**APPLICATION FOR PERMISSION
UNDER SECTION 16 OF
THE TOWN PLANNING ORDINANCE
(CAP.131)**

(a) Proposed use(s)/development 擬議用途/發展	Temporary Logistics Centre with Ancillary Office & Parking of Vehicle for a Period of 3 Years (Please illustrate the details of the proposal on a layout plan) (請用平面圖說明擬議詳情)

**Geotechnical Planning Review Report (GPRR)
for
Temporary Logistics Centre with
Ancillary Office and Parking of Vehicle for
a Period of 3 Years at
Various Lots in D.D.129 & adjoining Government Land
Lau Fau Shan, Yuen Long, N.T.
(Application No. A/YL-LFS/426)**

Drawing Title : Fire Service Installation Layout Plan

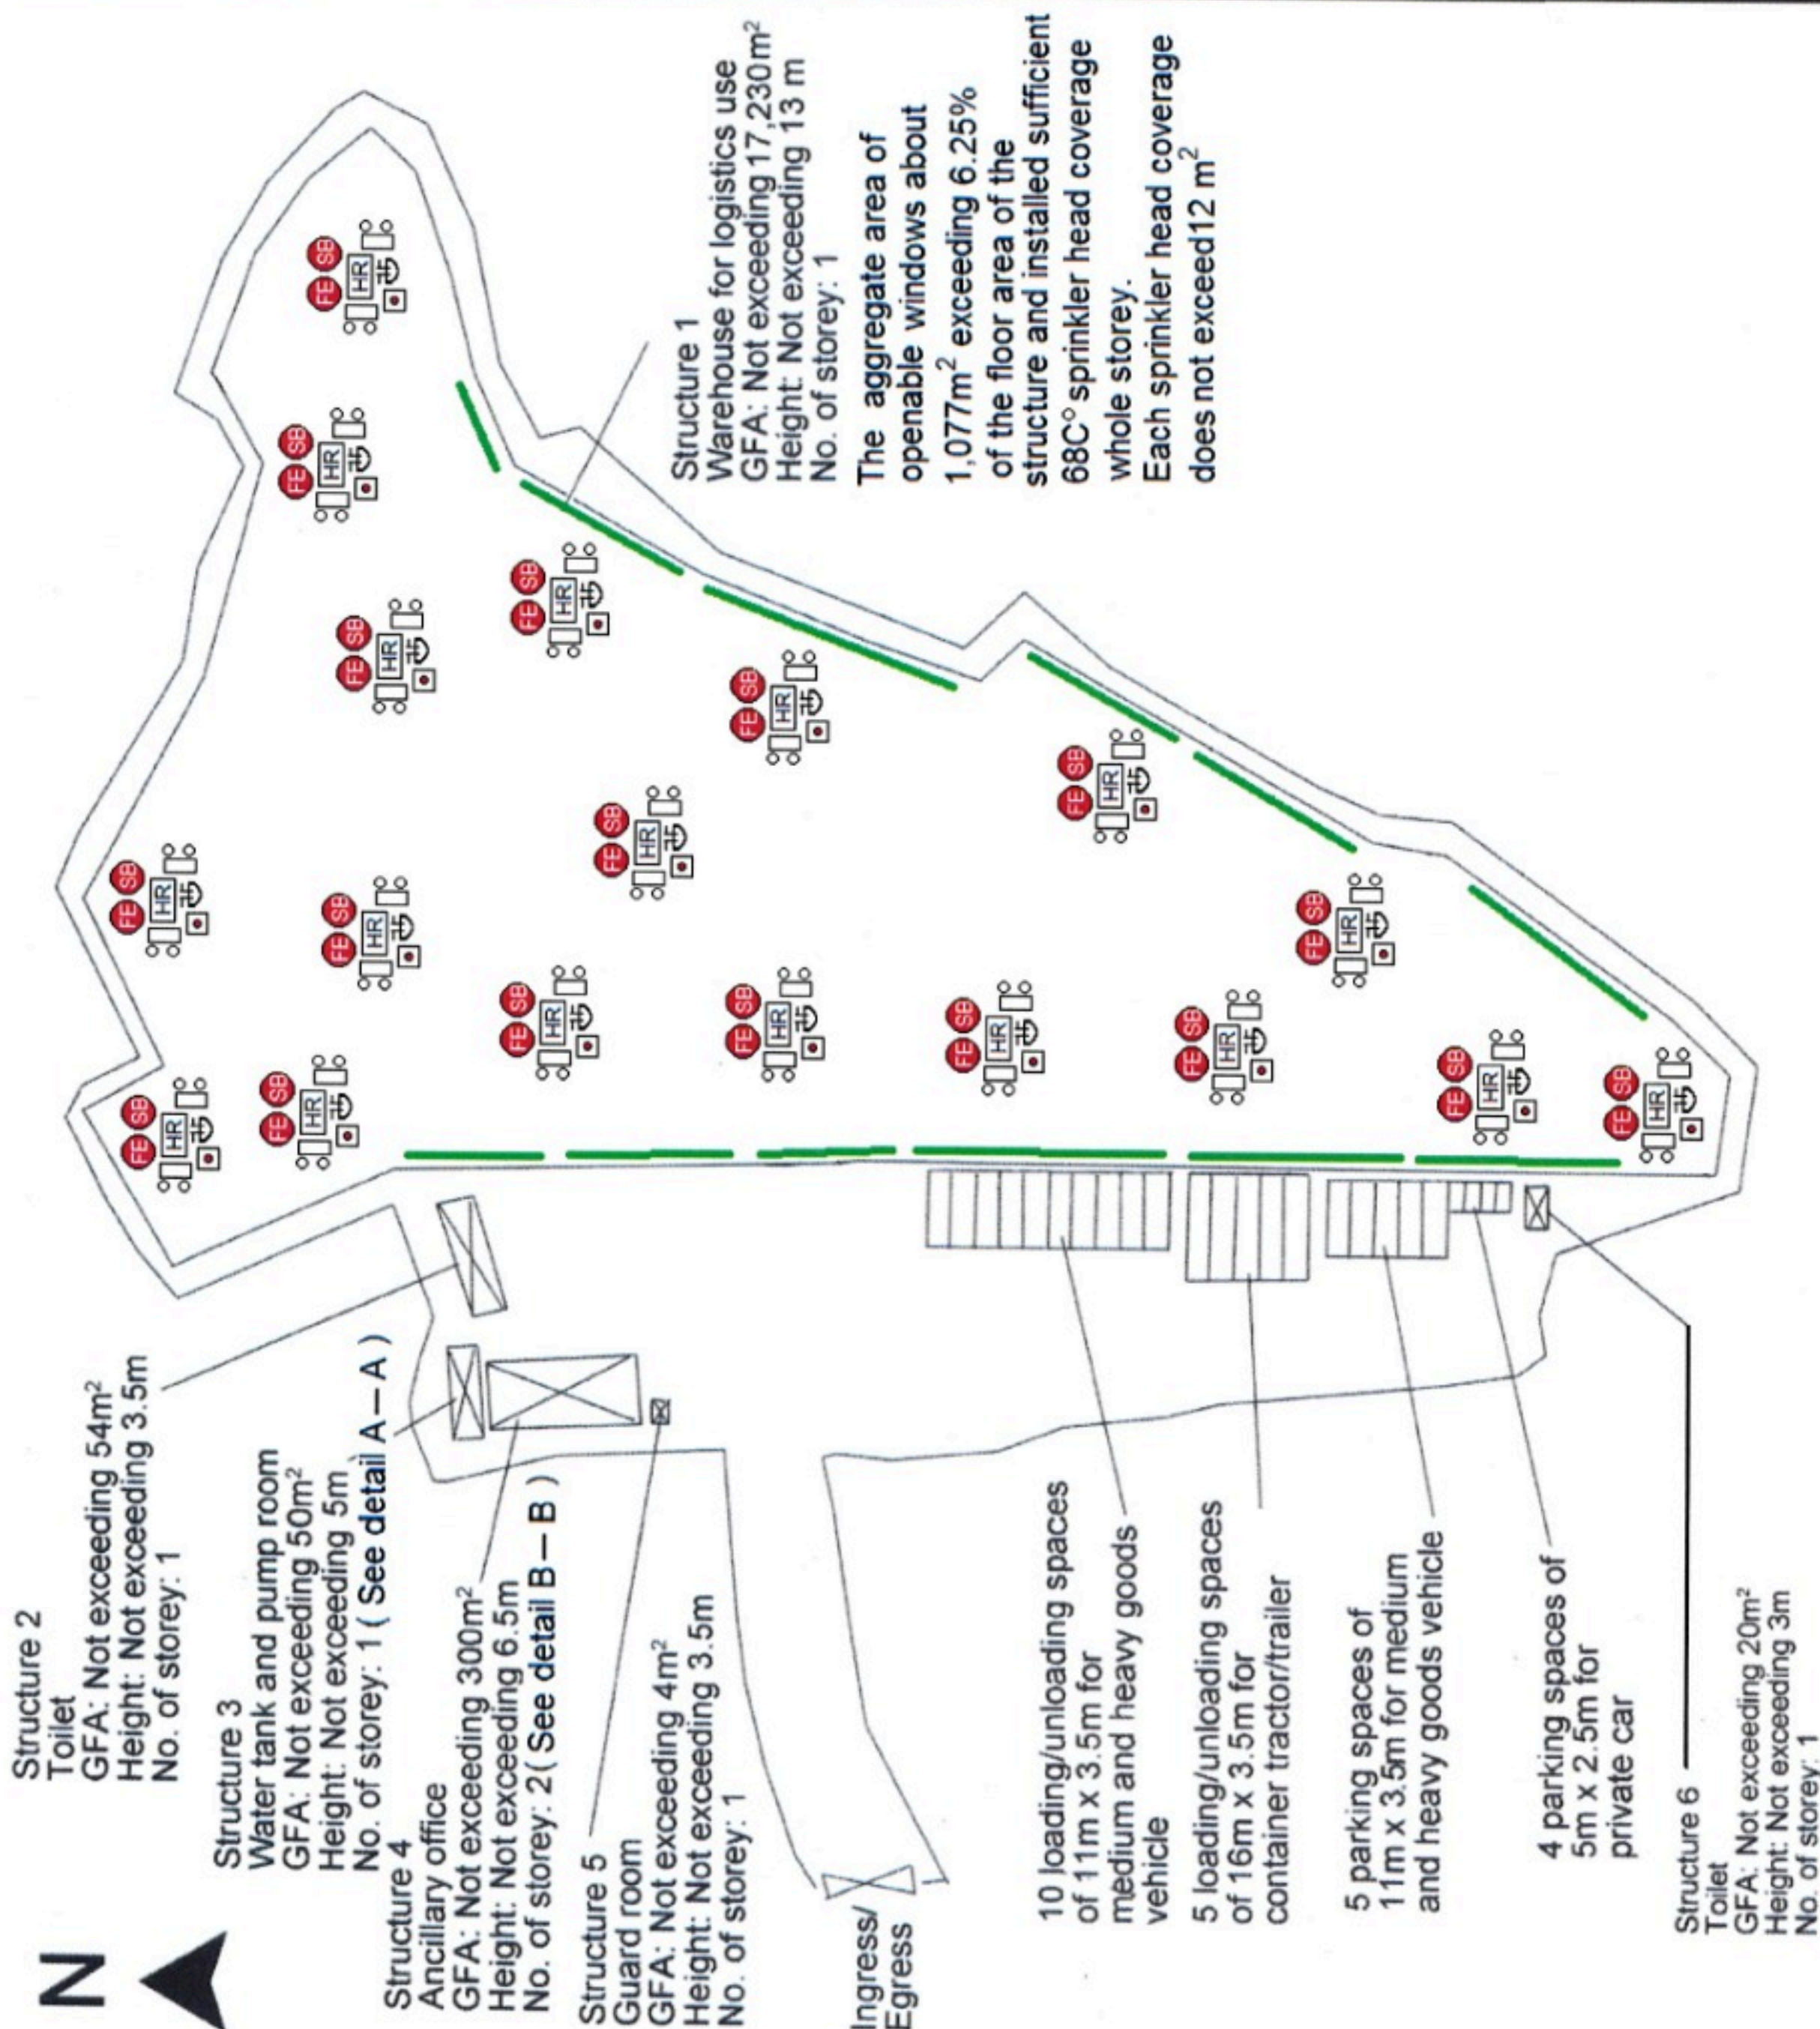
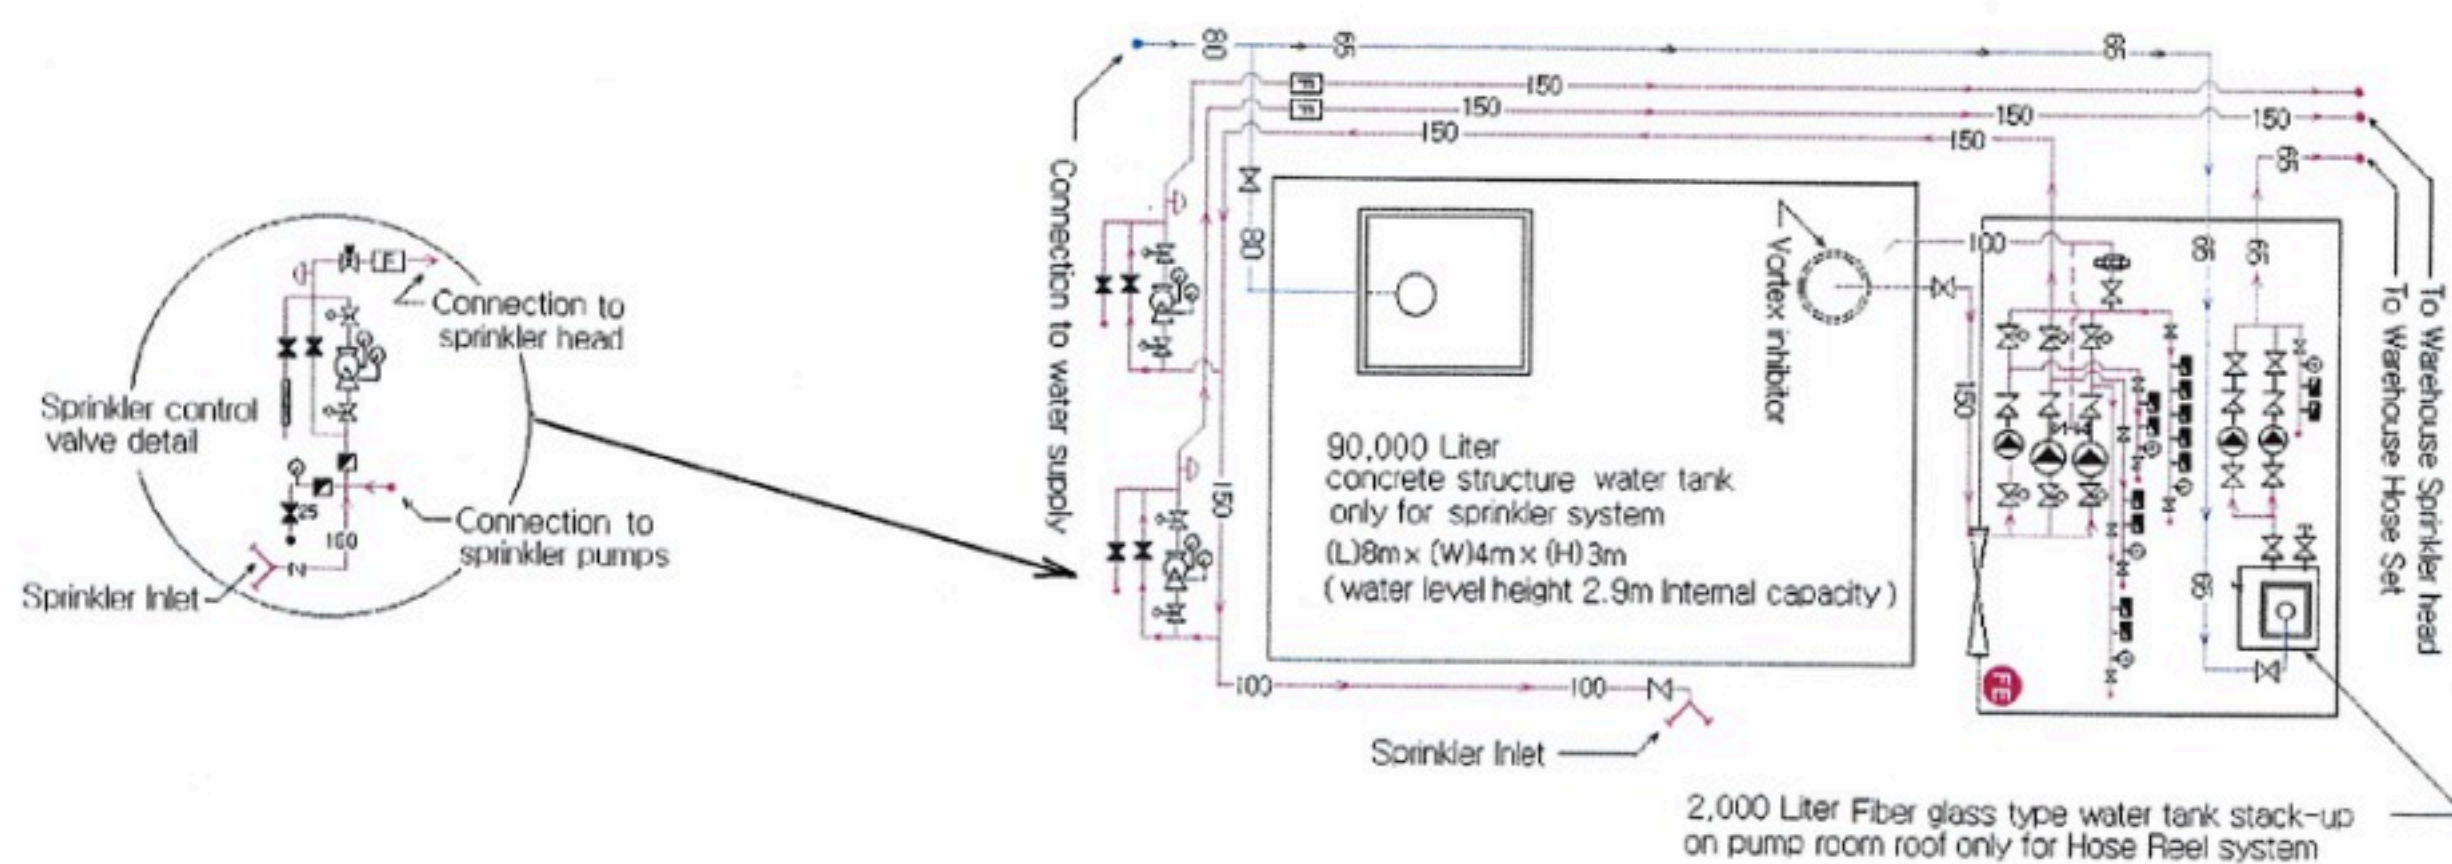
For the submission of updated FSI proposal on 24.6.2022, we confirm that the water tank and pump room is included in Structure 3 as shown in the proposed layout plan (Figure 3). They are shown separately in the FSI plan in order to show clearly to Director of Fire Services that the location of the water tank and pump room.

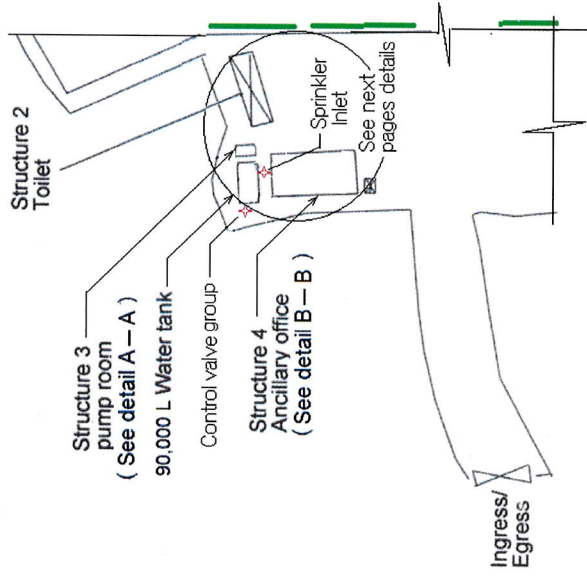
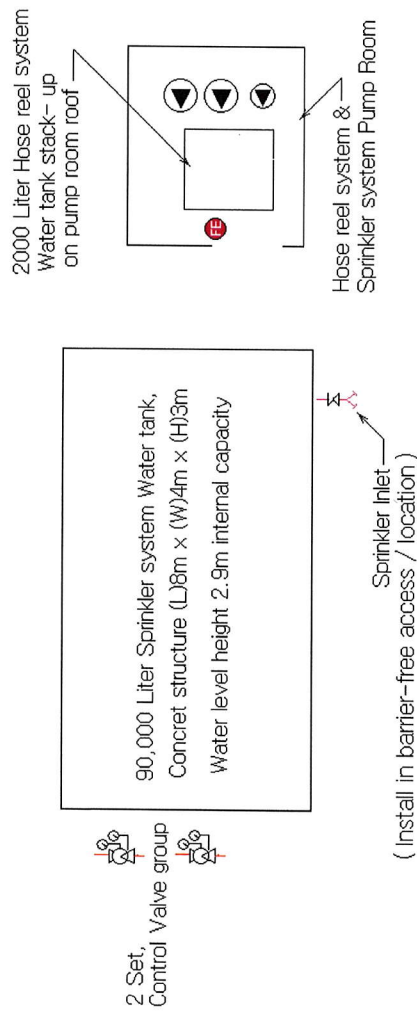
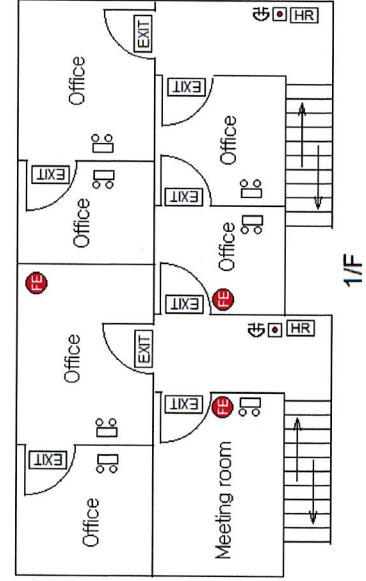
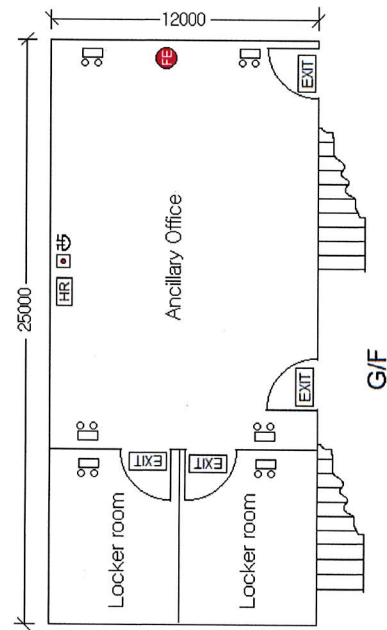
Comments of Director of Fire Services	Applicant's response
a. Location of sprinkler inlet, control valve, FS tank, sprinkler tank, FS pump and sprinkler pump shall be clearly indicated on plan;	Noted. Please see the updated plan.
b. Schematic drawing would not be vetted at this stage;	Noted.
c. Sprinkler system, modified hose reel system, fire alarm system, emergency lighting and exit sign shall also be provided for Structure 4;	Noted.

d. Elevation plan showing the location and dimension of openable windows shall be provided;	Noted.
e. Re. FS Note 13, "Fire Service Communication" shall be amended as Fire Services Communication Centre; and	Noted.
f. Provision of ventilation/ air conditioning control system shall be stated on FS Note.	Noted.
